Horsley Witten Group

March 9, 2007

**Re: Notice of Intent Review – Herring Brook Meadow, Scituate, Massachusetts
DEP File # SE-068-1988**

FEMA Flood
 Herring Brook Meadow
 Scituate, MA

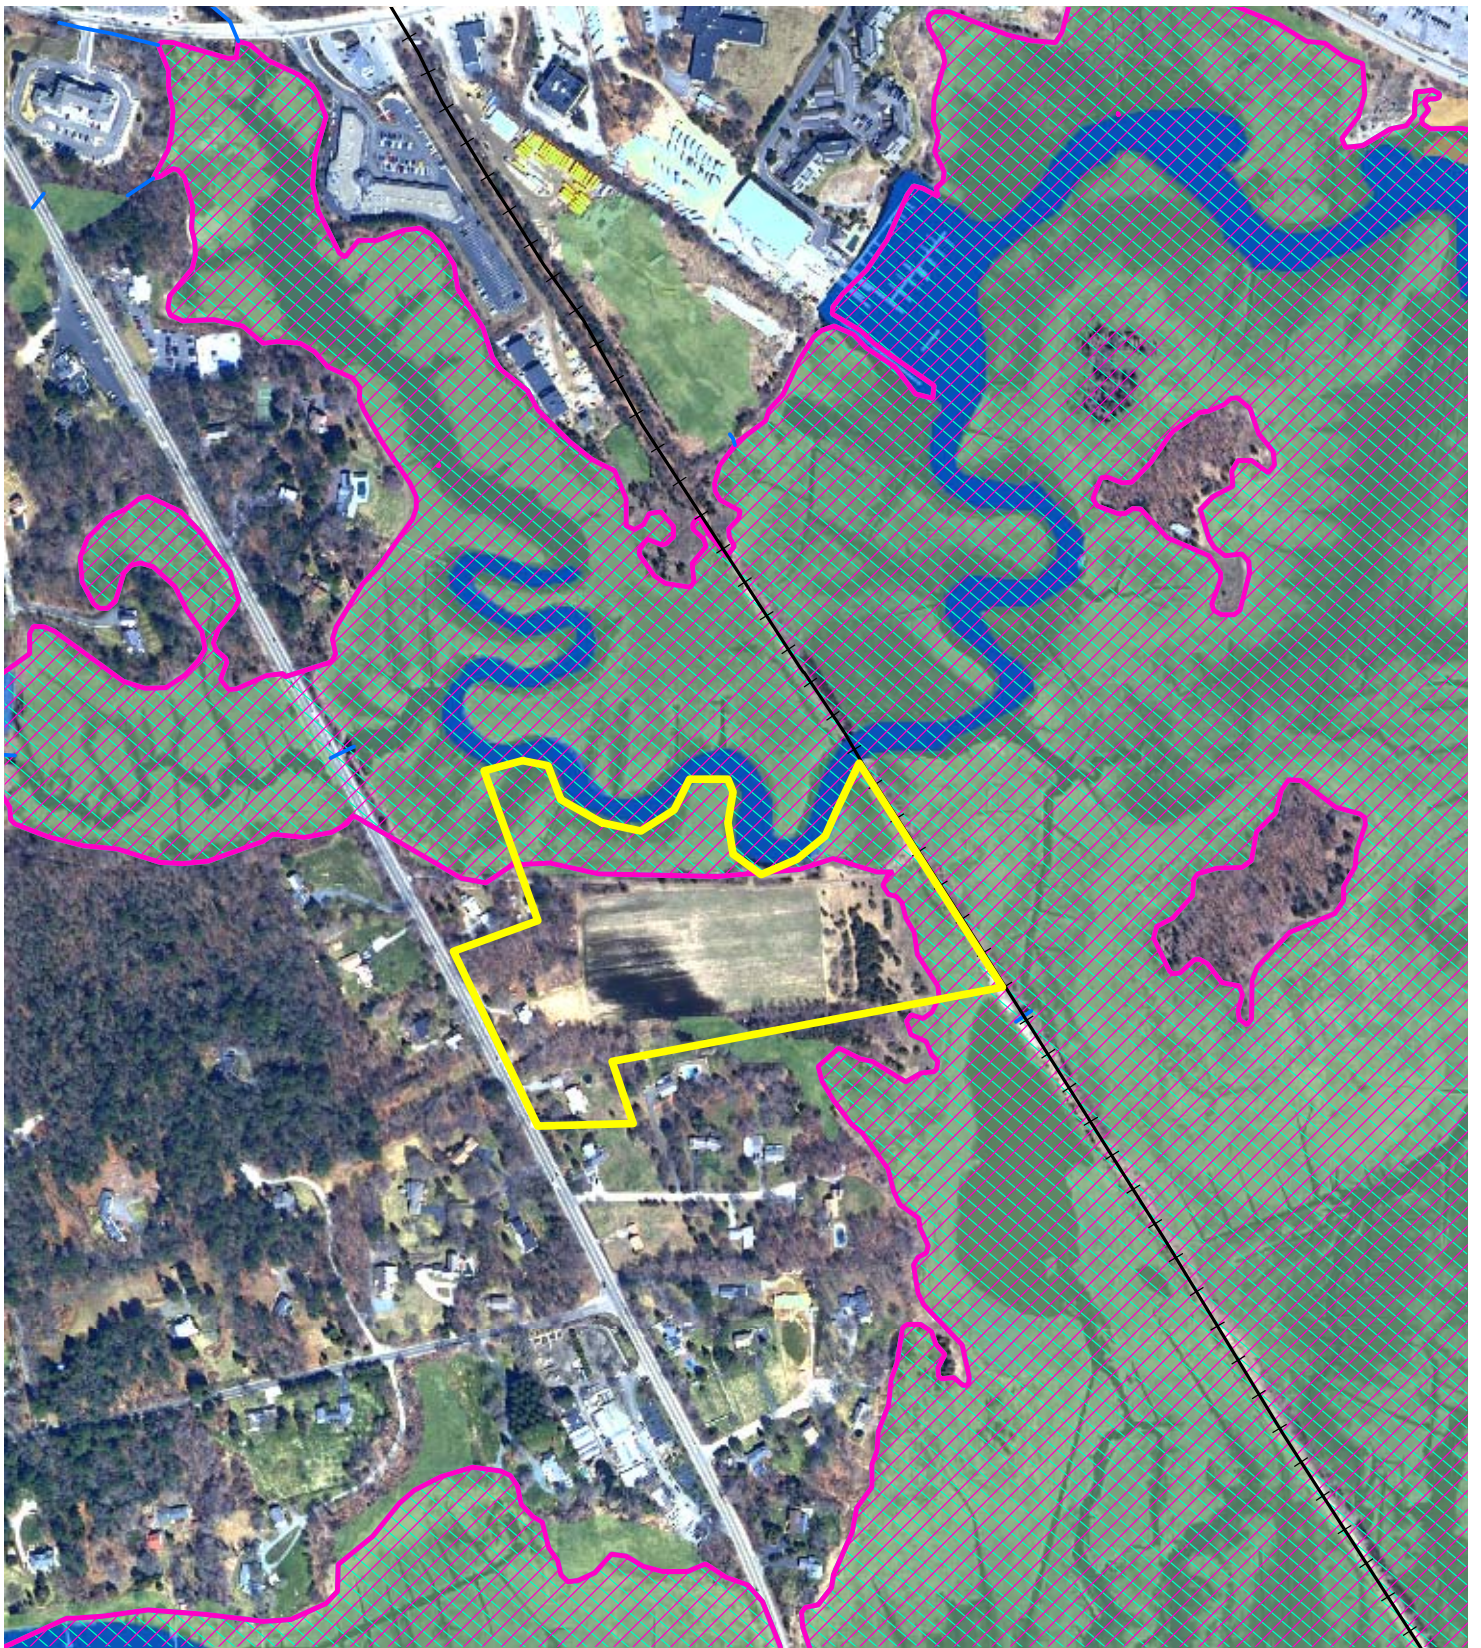
The property is located within the AE floodzone (LSCSF), as regulated by the Federal Emergency Management Agency (FEMA). The National Flood Insurance Program (NFIP) Flood Insurance Rate Map shows the site's AE flood Zone at elevation 11 (Figure 3). Land Subject to Coastal Storm Flowage is defined at 310 CMR 10.04 as *land subject to any inundation caused by coastal storms up to and including that caused by the 100-year storm, surge of record or storm of record, which ever is greater.*

Although there are no performance standards within the WPA Regulations for LSCSF, it is generally accepted that LSCSF is significant to the interests of storm damage prevention and flood control. The applicant proposes to place substantial amounts of fill within LSCSF (up to seven vertical feet of fill material). This amount of fill has the potential for altering storm surge flow patterns, increasing the potential for off-site flooding, and arguably altering existing drainage patterns at this site. Section 10.38 of the Town of Scituate Wetlands Rules and Regulations discusses the importance of velocity zones (VE-Zones) and AE-Zones for storm damage prevention and flood control. The general performance standard of this section states: "*any activity shall not have an adverse effect by increasing the elevation or velocity of flood waters or by increasing flows due to a change in drainage of flowage characteristics on the subject site, adjacent properties...*" The Commission may want to request that the applicant provide the Commission with data demonstrating how this project will meet this performance standard.

- Request that the applicant submit additional information (calculations, studies, plans) demonstrating that the proposed alterations within LSCSF will not have an adverse affect by increasing the elevation or velocity of flood waters, increasing or changing drainage flow characteristics, or increasing flooding on adjacent properties.
